COLORADO
Division of Reclamation,
Mining and Safety
Department of Natural Resources

Permit Number: C-1981-018 Mine Name: Deserado Mine Operator: Blue Mountain Energy, Inc. Operator Address: Mr. Kurtis Blunt 3607 County Road 65 Rangely, CO, 81648	County: Moffat, Rio Blanco Operation Type: Underground Permit Status: Active Ownership: Private
	Operator Representative Present: NA
Operator Representative Signature: (Field Issuance Only)

Inspection Start Date: December 9, 2020 Inspection Start Time: 10:00 Inspection End Date: December 9, 2020 Inspection End Time: 10:05		Inspection Type: Aerial Inspection Inspection Reason: Normal I&E Program Weather: Clear	
Joint Inspection Agency: None		Joint Inspection Contacts: None	
Post Inspection Agency: None		Post Inspection Contacts: None	
Inspector(s): Clayton Wein Brock Bowles	Inspector's Signature: <i>Clayton Wein</i>		Signature Date: 12/10/2020

Photo 2: The B Seam Dewatering System No. 1

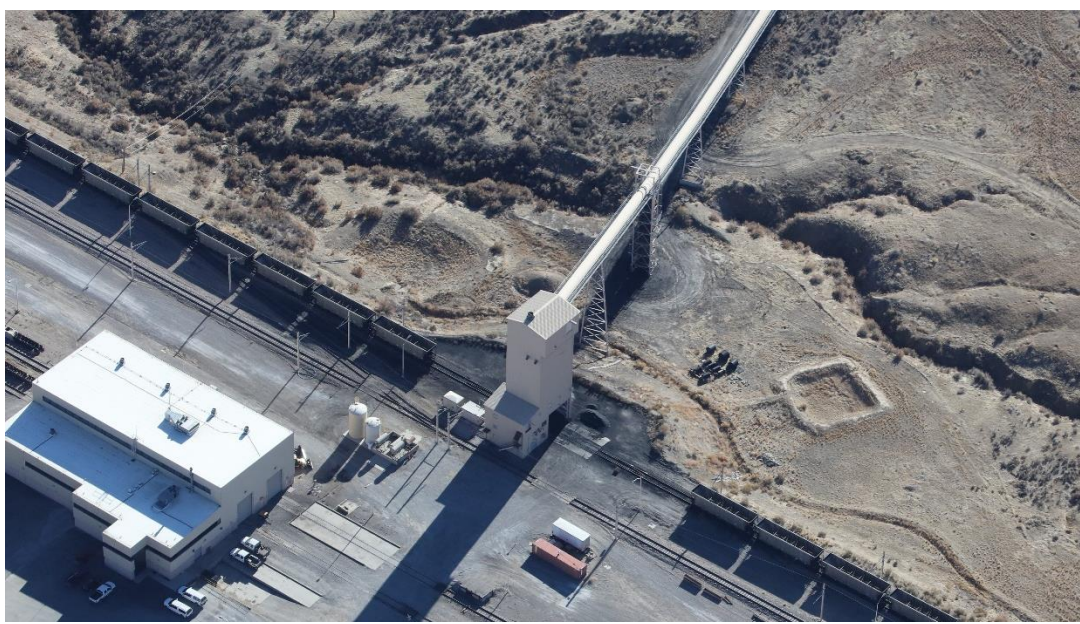
All cells of the B Seam Dewatering System No. 1 were holding water (Photo 2). The water was frozen in all of the cells. The level of water impounded in the Last Chance Pond appeared to be below the level of the primary spillway. The embankments for the cells were stable and vegetated. There were no erosional features identified.
